EIA Scoping Direction

DNS CAS-02977-Y9F1W7 - Convatec
Green Manufacturing Hub Rhymney

07/03/2024

23/0792/DNS

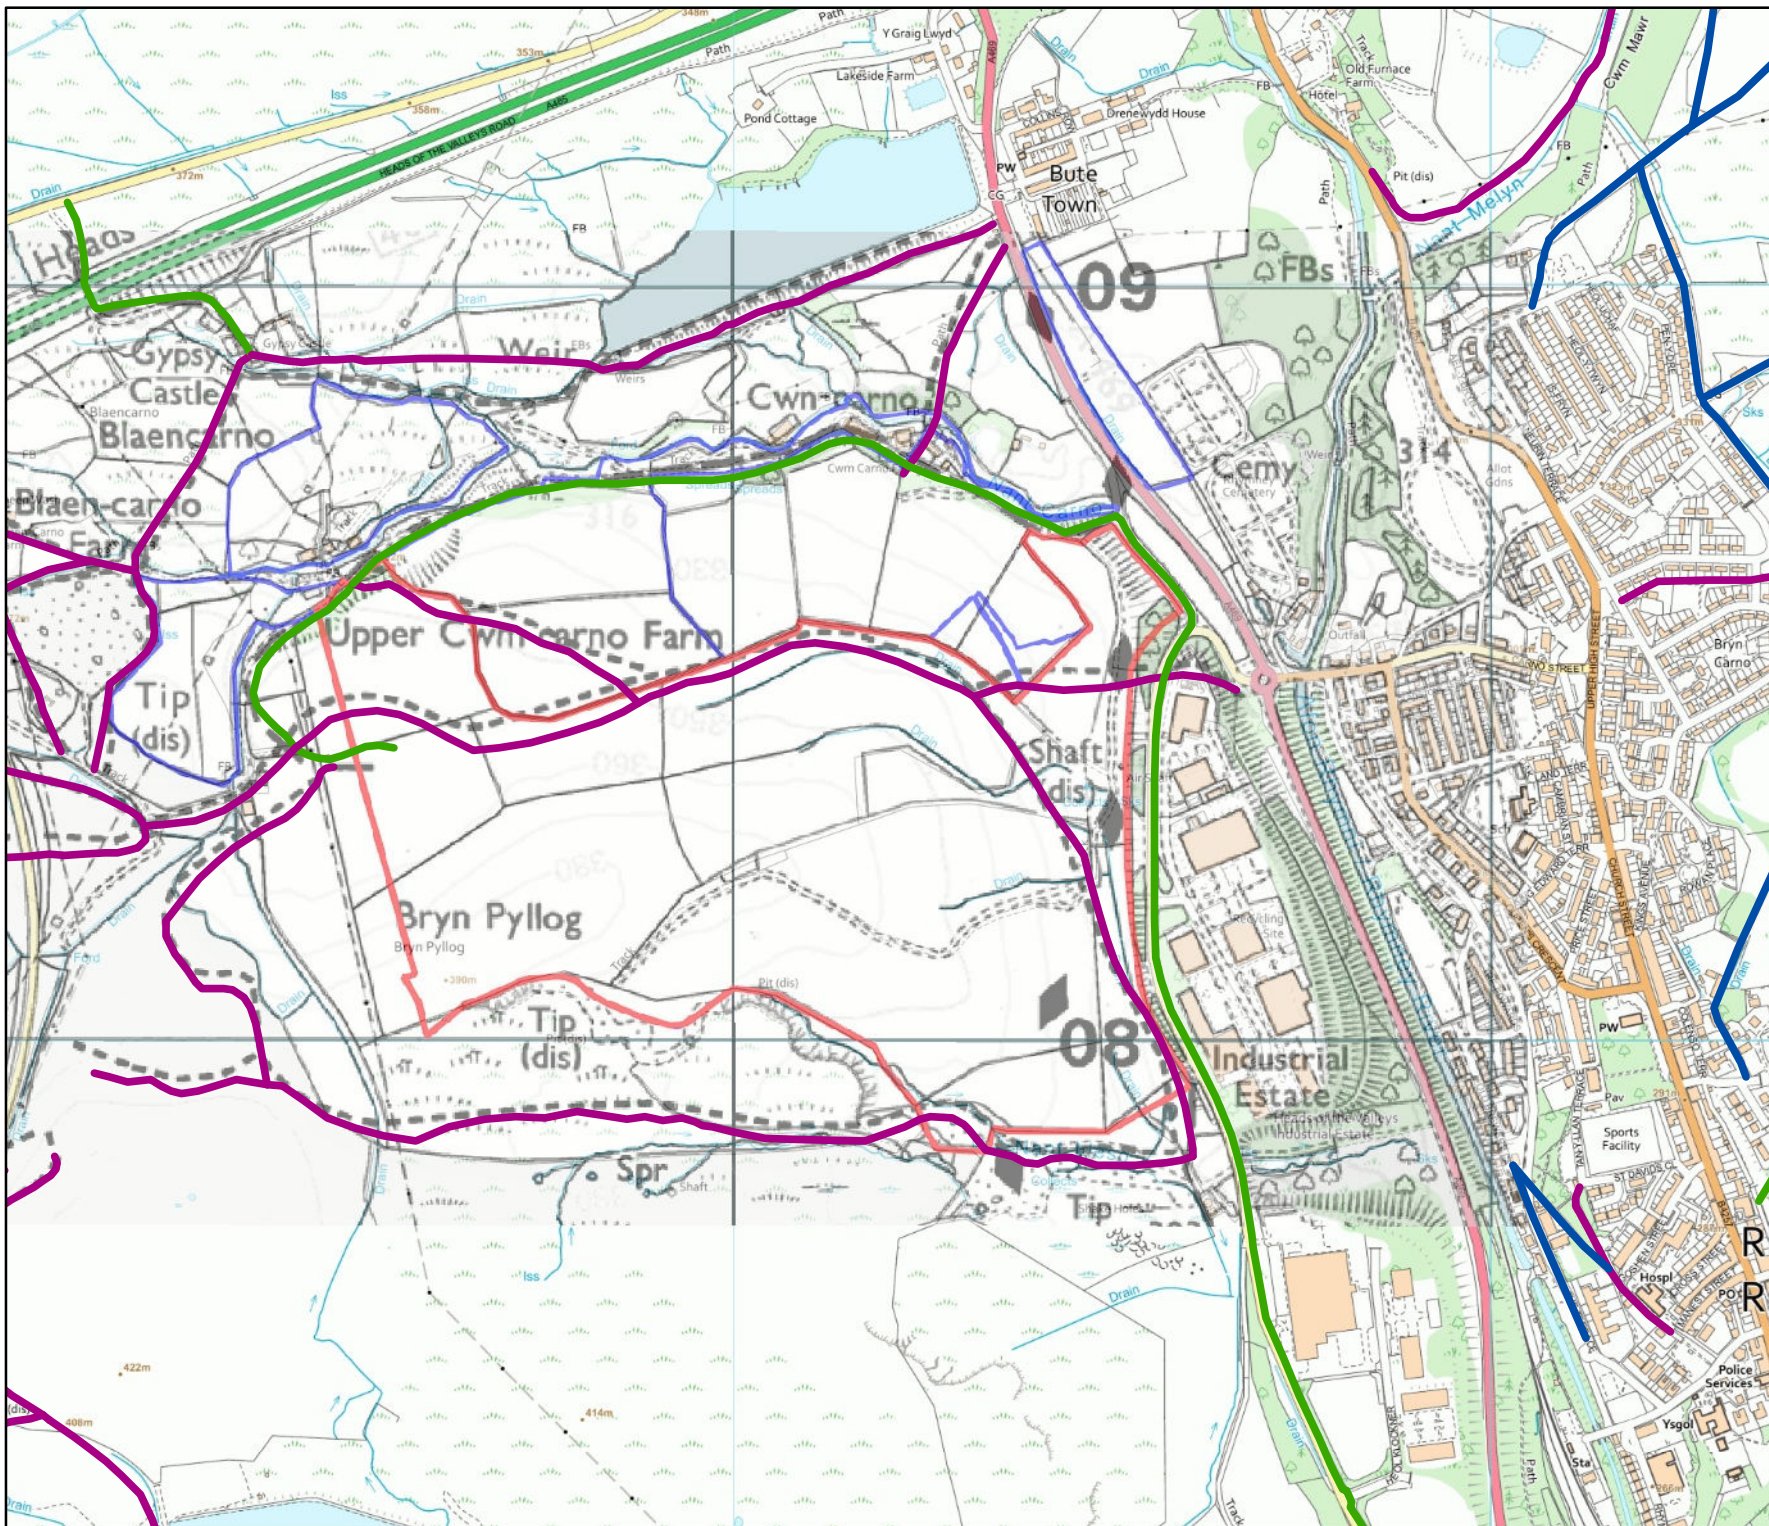
- 4) No fencing shall be erected on or within 1 metre of the public right of way as shown on plan ref. 23-0792-DNS-PROW.pdf

- 5) No excavation or tipping of surface material or temporary storage of soils or other materials shall take place closer than 2 metres to the public right of way as shown on plan ref. 23-0792-DNS-PROW.pdf
